COTTONWOOD GROVE 3RD ADDITION

Re: S/D 98-3 -- Final Plat of COTTONWOOD GROVE 3RD ADDITION

At the regular meeting of the Subdivision Committee of the Metropolitan Area Planning Commission on Thursday, May 7, 1998, the above captioned plat was considered. The action of the Committee was to approve the final plat, subject to the following:

CASE NUMBER: S/D 98-3 - COTTONWOOD GROVE 3RD ADDITION

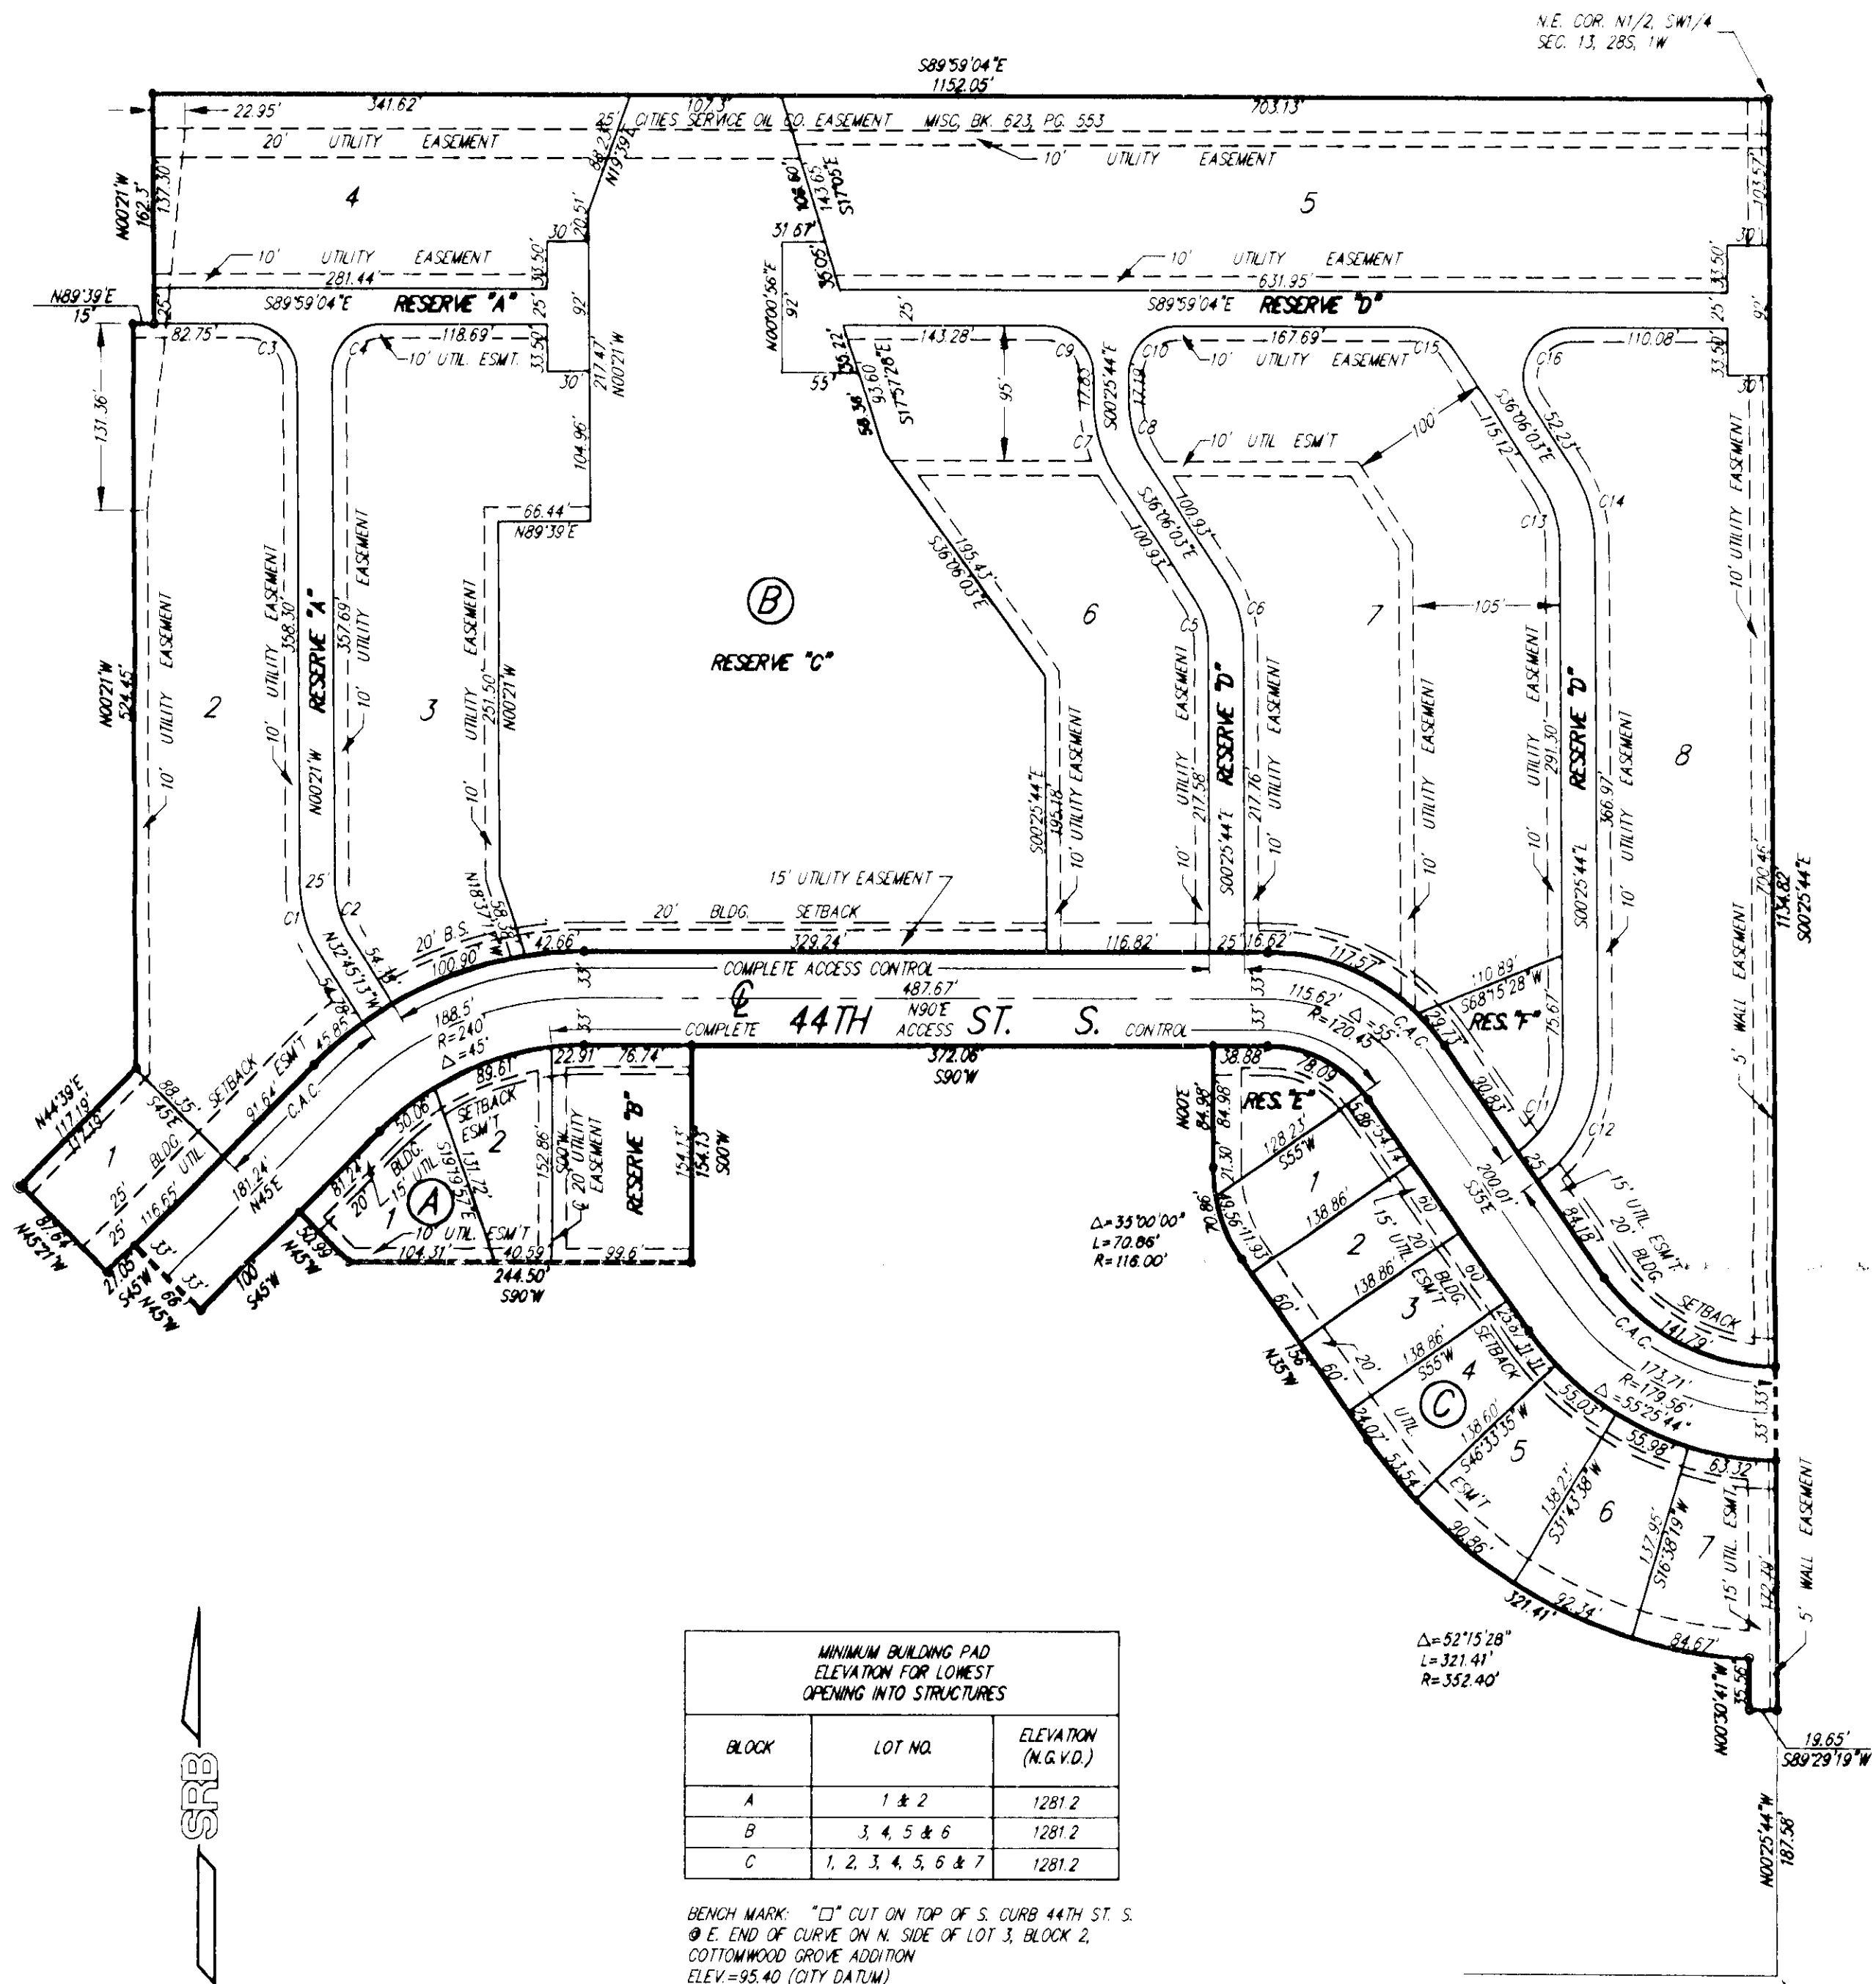
- A. The applicant needs to guarantee the extension of City water and sanitary sewer to serve the lots being platted. City Engineering needs to comment on the need for any additional guarantees for municipal services. City Engineering requests a sanitary sewer layout to determine location of easements.
- B. If improvements are guaranteed by petition, a notarized certificate listing the petitions shall be submitted to the Planning department for recording.
- C. City Engineering needs to comment on the status of the applicant's drainage plan. The drainage plan is approved. A guarantee will be required and minimum pads need to be platted for the lots adjacent to the lakes.
- D. Complete access control shall be dedicated along 44th Street South except at the location of the private street reserves and except along the single-family lots.

The final plat indicates the requested access controls. The final tracing needs to denote access controls along the south side of 44th St. South.

- I. The applicant shall also guarantee the paving of 44th Street South to collector street standards, including sidewalks on both sides.
- J. The final plat shall indicate temporary turnarounds at the terminus of the private streets at the east and west line of the plat, and adjoining Reserve C. A "T"-type turnaround may be provided as an alternative to the standard circular turnaround for the terminus of the private streets adjoining Reserve C. Dedication of the temporary easements by separate instrument shall be provided.

- K. Fire Department needs to comment on the acceptability of the private street access. *Fire Department requests a temporary cul-de-sac at the terminus of 44th St. South along the east line of the plat.*

- M. The applicant's agent shall determine any setback requirements for the pipeline by researching the text of the pipeline agreement. If a setback from the pipeline easement is provided for in the pipeline easement agreement, it shall be indicated on the face of the plat.
